BULLETIN #: 13T-04A

SUPERSEDES: 13T-04 dated Nov-11-2013

**SUBJECT:** Unloader valve changes for recip compressors TECHNICAL MARKETING

The old and new valves can be readily differentiated by the shape of their stem retainers. See Figures 1 and 2.

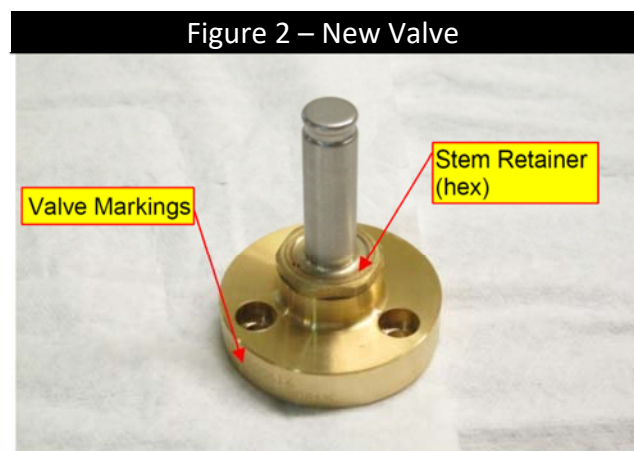
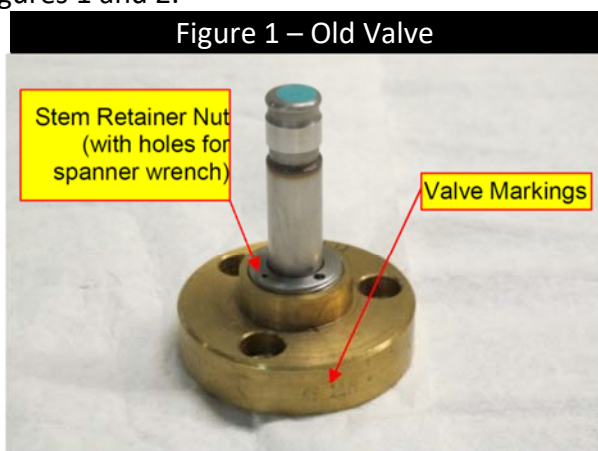
Change in manufacturer of unloader valves resulting in change in unloader valve part numbers. The old and new part numbers are given in Table 1.

They can also be identified by the markings located on the side of the valve.

“06DA405264”, “06DA408824”, “06DA405244”, or “06DA408834” (either of the four)

“2ADB000616”
